PLANNING & ZONING COMMISSION
MEETING
SAMUEL E. DEAN BOARD ROOM
BUTLER GOVERNMENT CENTER
1200 OAK BROOK ROAD
OAK BROOK, ILLINOIS
630-368-5000

Special Meeting
Wednesday, December 18, 2024
6:30 PM

FINAL PLAT OF ABROGATION & CONSOLIDATION
2903 OAK BROOK HILLS CONSOLIDATION

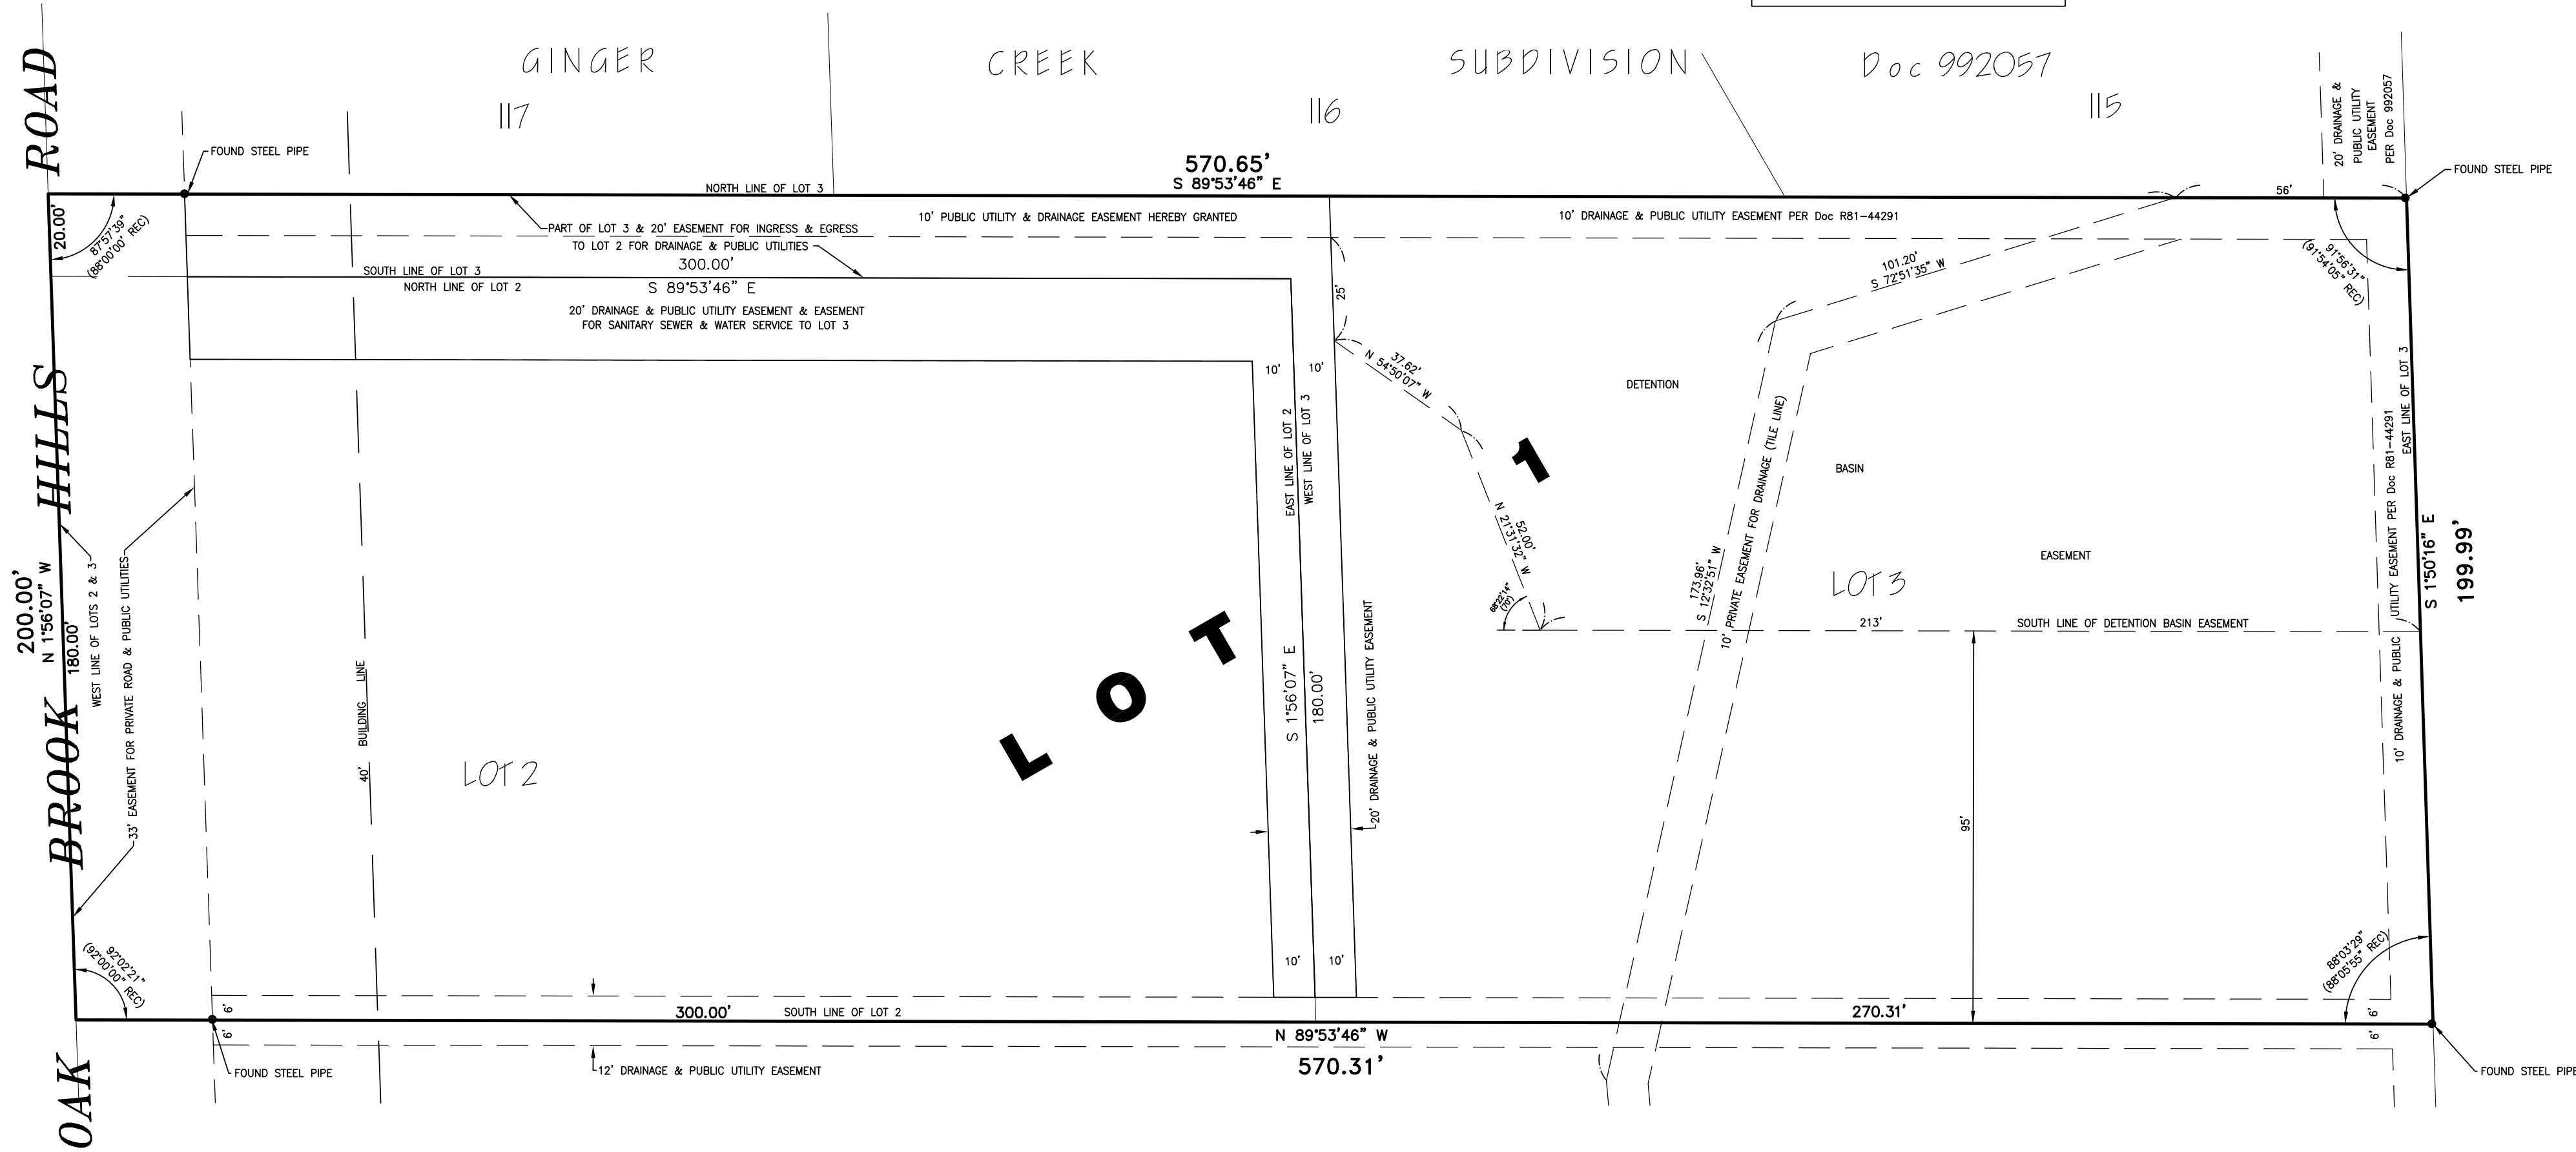
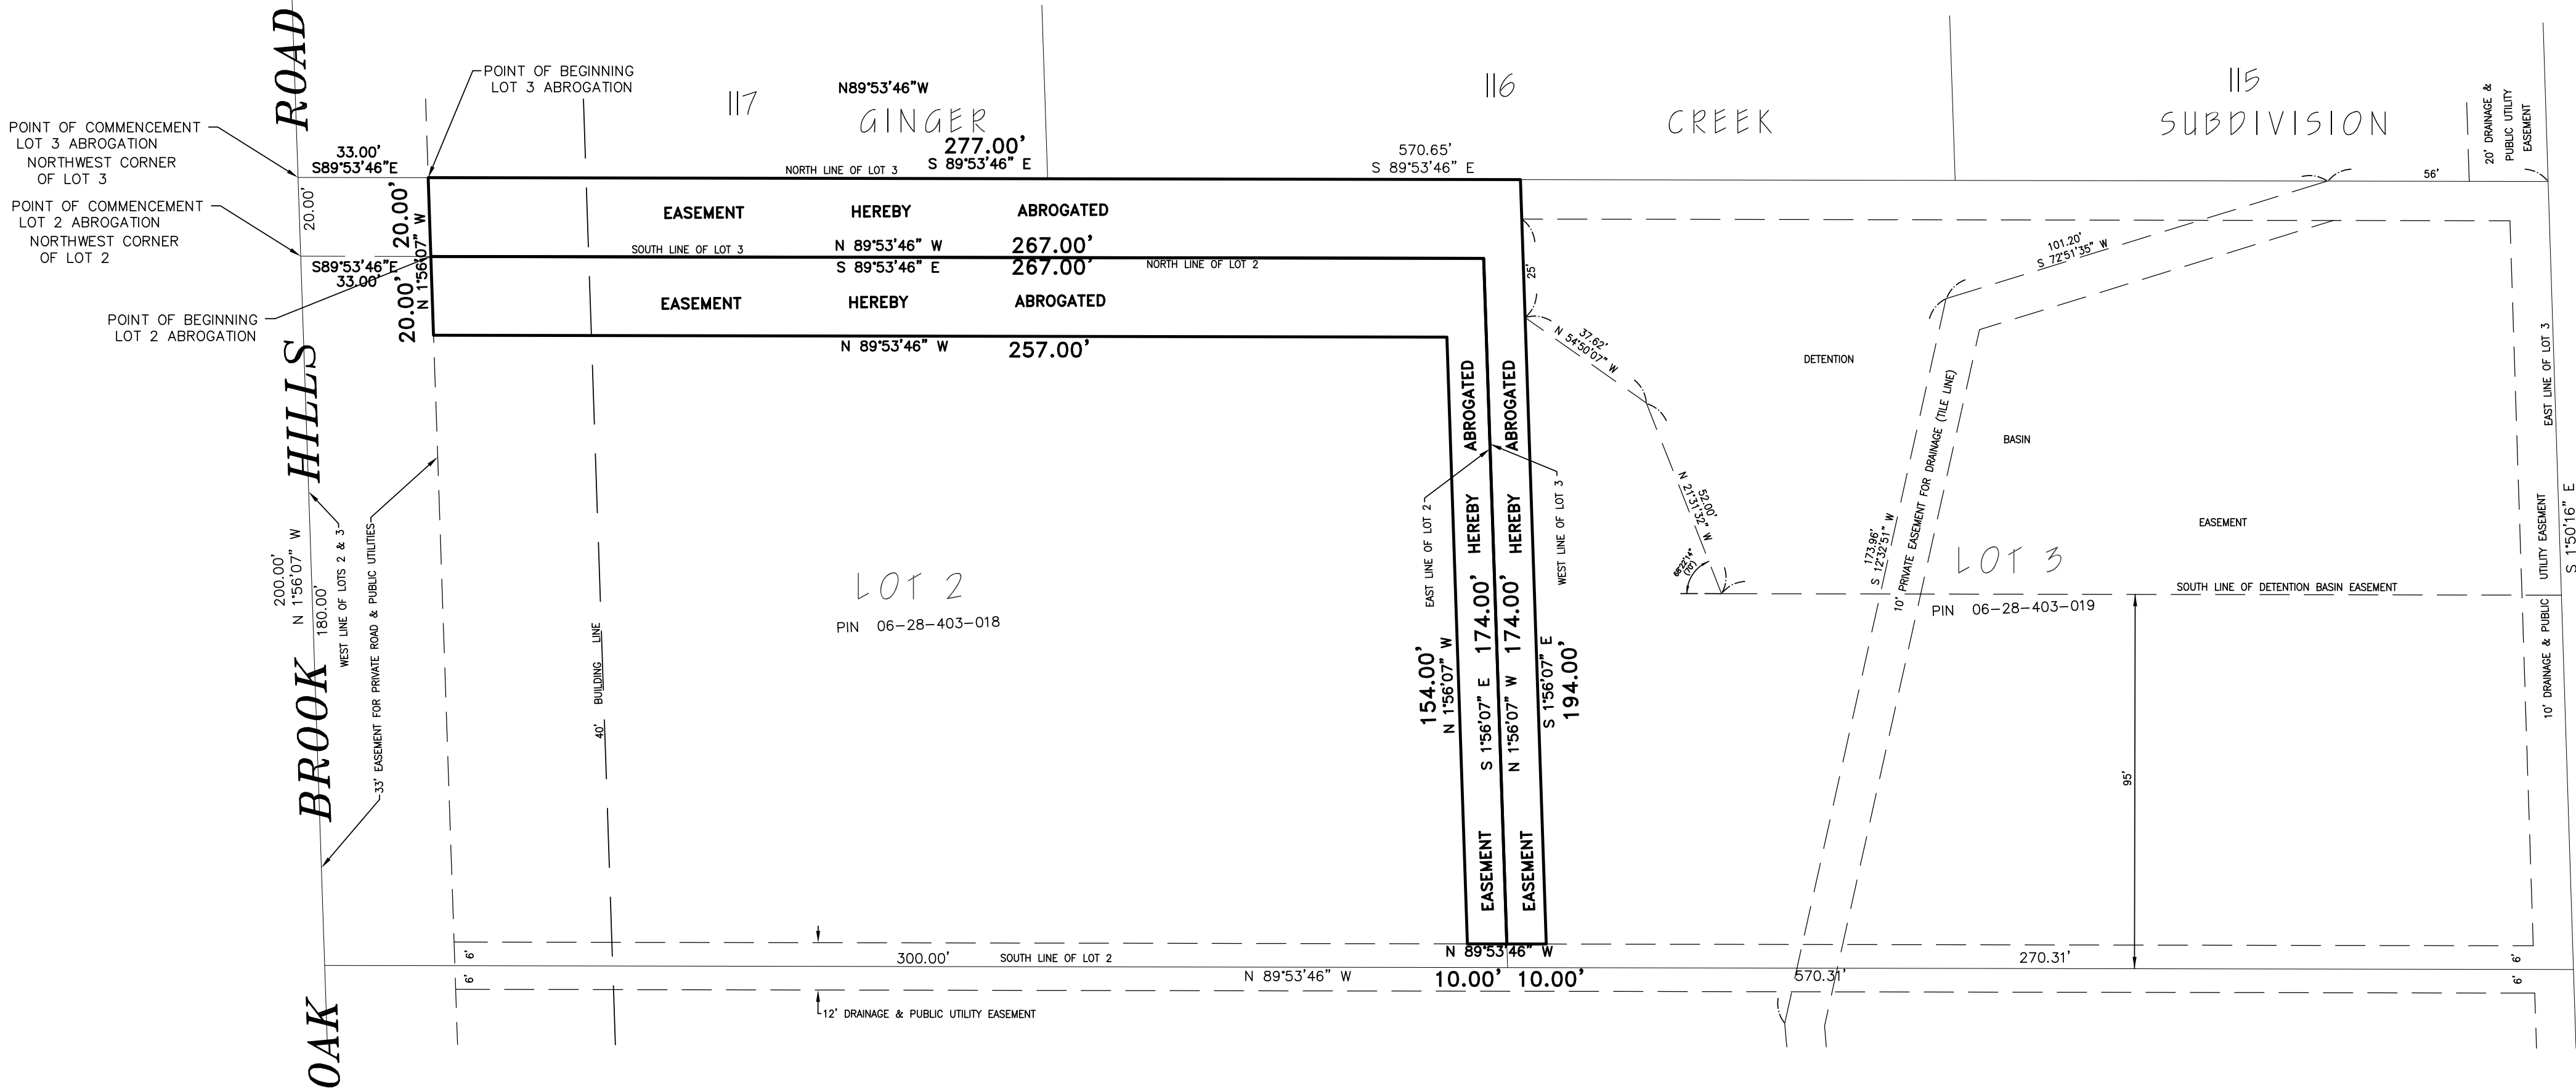
3. Title 14-4-2.C.2 – Grant a 10' Public Utility and Drainage Easement along the north property line where the 20' ingress/egress easement was located.
4. Title 14-4-2.D.2 – Please fix the lines for the "State of" and "County of" in the Notary Public Certificate.
5. Title 14-4-2.D.3 – Update the expiration date for the Professional Land Surveyor license for Mark H. Landstrom, PLS.
6. Remove the Oak Brook Department of Public Utilities certificate.

3. Title 14-4-2.B.1 – Include the word **FINAL** prior to PLAT OF CONSOLIDATION at the top of the sheet.
4. Title 14-4-2.B.2 – Please use the language in the legal description (provided in the Land Surveyor Certificate) as the legal description at the top of the sheet.
5. Title 14-5-2.B.5 – Provide a date of preparation.
6. Title 14-4-2.C.2 – Please address easement requirements as follows:
 - The 20' Easement for Ingress & Egress to Lot 2 for Drainage & Public Utilities (Part of Lot 3) along the north property line shall be vacated.
 - The 20' Drainage & Public Utility Easement & Easement for Sanitary Sewer & Water Service to Lot 3 shall be vacated.
 - A 10' Public Utility and Drainage Easement shall be granted along the north property line where the 20' ingress/egress easement was located (see first easement vacation requirement).

7. Title 14-4-2.D.1 – Revise the title and language to match the Owner's Certificate. Add a separate School District Certificate. All certificate language can be found in Title 14-7-5.

8. Title 14-4-2.D.2 – Revise the title and language to match the Notary Certificate.
9. Title 14-4-2.D.3 – Revise the title from Land Surveyor to Surveyor's Certificate.

10. Title 14-4-2.D.4 – Revise the title and language to match the County Clerk Certificate.
11. Title 14-4-2.D.7 – Revise the title from Village Engineer to Village Engineer's Certificate.

12. Title 14-4-2.D.8 – Revise the title from Special Assessments to Certificate As To Special Assessments.
13. Title 14-4-2.D.9 – Revise the title from Plan Commission to Planning & Zoning Commission Certificate. The certificate language shall be revised to read, "APPROVED BY THE PLANNING & ZONING COMMISSION OF THE VILLAGE OF OAK BROOK..."

14. Title 14-4-2-D.10 – Revise the title from Village Clerk to Village Clerk's Certificate.
15. Title 14-4-2-D.11 – Revise the title from DuPage County Recorder to County Recorder's Certificate.
